# Building Enclosure Warranty Review

The Taylor, 550 Taylor Street, Vancouver, BC

REPORT 2688.00

DATE May 7, 2007

Figure 2.1.2.1. - Masonry Detail D1A-26.

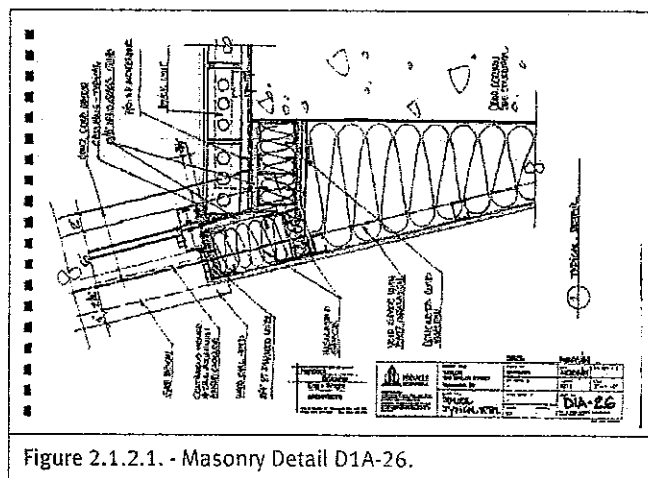
1. Detail D1A-26 (Fig. 2.1.2.1) illustrates a situation at the high-rise where lightweight steel framing has been used to frame in areas between structural concrete and windows. This wall is similar to Assembly 1, but instead of concrete there is sheathing. **Significance:** The self-adhered membrane on the sheathing has low vapour permeance; therefore there exists the possibility of condensation on the sheathing. A risk for deterioration exists because sheathing is less durable than concrete. It may have been

preferable to use a more permeable sheathing membrane than the self-adhered membrane shown. However, we could not confirm what the as-built condition was, we recognize that these areas may be limited, and the transitions between window/sheathing and sheathing/concrete required self-adhered membrane stripping, therefore limiting the area for vapour permeable sheathing membrane. Exploratory openings should be made at select locations to check the condition of the sheathing within 5 years.

Figure 2.2.2.3. - Poorly fitted weather-stripping at Townhouse 4 rear door.

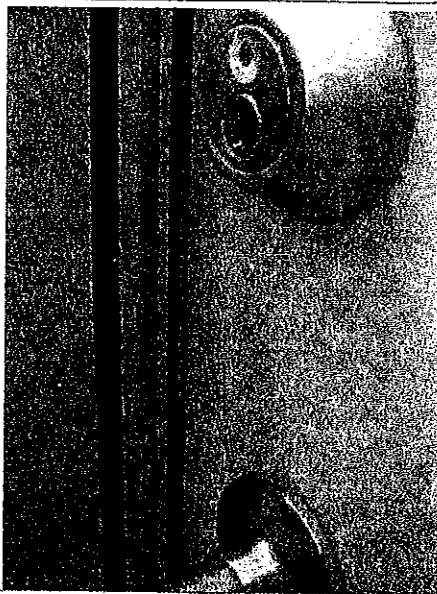
At many townhouse doors there is air leakage because the weather-stripping is not tight to the doors (Fig. 2.2.2.3). At some high-rise suites, occupants complained of drafts at the balcony doors. **Significance:** Energy loss, lack of comfort.

Figure 2.3.1. - No soffit insulation at Suite 510 enclosed balcony (red arrow). Note the soffit insulation at the adjacent area (yellow arrow).

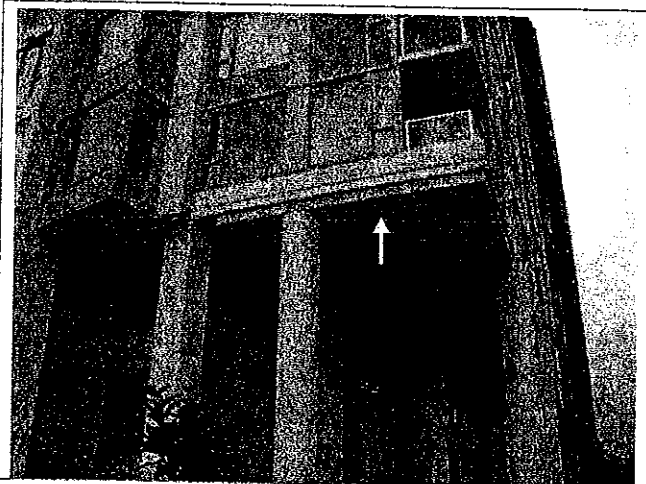
1. Reported cold floors at enclosed balconies of Suite 510 (Fig. 2.3.1) and townhouses (Fig. 2.3.2). Enclosed balconies are not considered occupied space; therefore there are no requirements for insulation (although the walls between the enclosed balcony and the suite must be insulated). However, some enclosed balconies (Suite 503) have soffit insulation and were detailed that way (Fig. 2.3.3 - Detail D1B-19A). Further to this, there are electric baseboard heaters in the enclosed balconies of Suite 510 and the townhouses we had access to (Townhouses 18 and 20), indicating that they may be considered occupied space, but they have no soffit insulation. See also 2.1.1 Architectural Concrete, item 4. **Significance:** Uncomfortably cold floors in the winter, virtually rendering the space unusable. Condensation at windows.

Figure 2.4.1. - Townhouse parapet Detail D1B-26A.

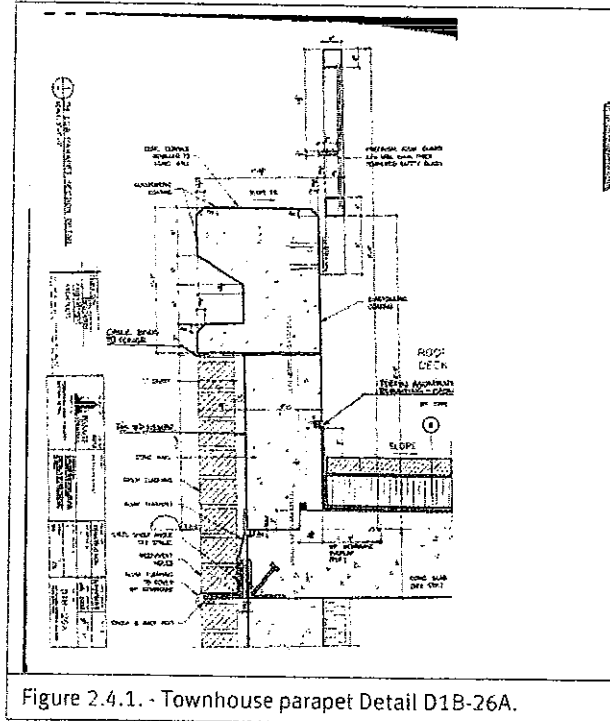
1. The as-built condition townhouse parapet detail varies from Detail D1B-26A (Fig. 2.4.1) in that there is no precast cornice with continuous waterproofing underneath (the cornice is poured-in place concrete instead, not precast), and the waterproofing membrane is not terminated 3" above the paver level. **Significance:** As-built detail is less reliable from a waterproofing perspective. Water staining on the ceiling in Townhouse 17 (252-35 Keefer Place) has been reported. Water ingress has been reported at Townhouse 19 (257-35 Keefer Place).

Figure 2.4.2. - Evidence of past water ingress at Suite 1607.

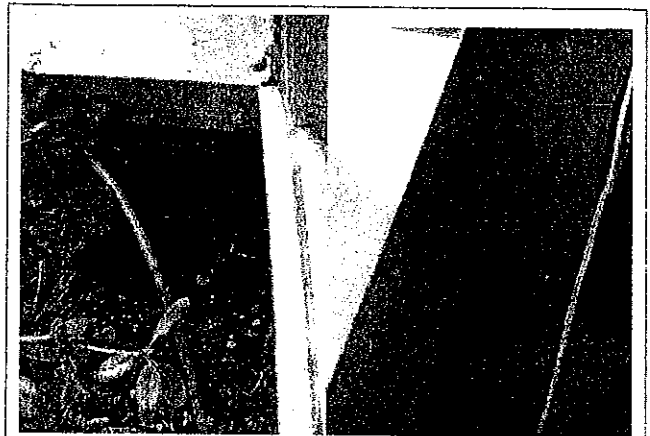
2. Evidence of past water ingress in master bedroom of Suite 1607 (Fig. 2.4.2). The origin of the water ingress is likely the planter on the deck outside. The planter has been partially excavated, however it is unclear if remedial work was conducted. The termination of the membrane lacks a reglet, base flashing, and sealant, as shown on Architectural Detail D1B.03. **Significance:** A nuisance to occupants, damage to interior finishes, and may lead to deterioration of moisture sensitive building components and fungal growth.

Fig. 2.5.1.2. - Exposed waterproofing membrane at the courtyard.

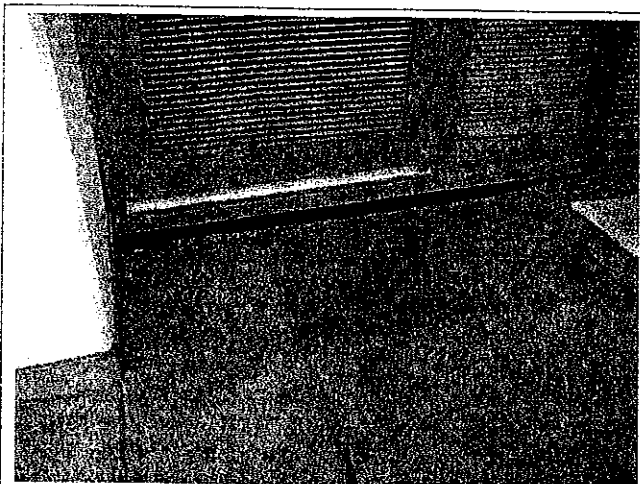
1. Exposed waterproofing membrane at the base of high-rise in the courtyard and at planters (Fig.2.5.1.2). The membrane must be covered at all locations. The terminations in the planters are missing a reglet, base flashing, and sealant, as shown on Architectural Detail D1B.03. **Significance:** Will result in premature deterioration of the membrane.
2. Missing sealant at metal flashing gum lip termination in the courtyard (Fig.2.5.1.3). **Significance:** May result in water ingress behind the waterproofing membrane.
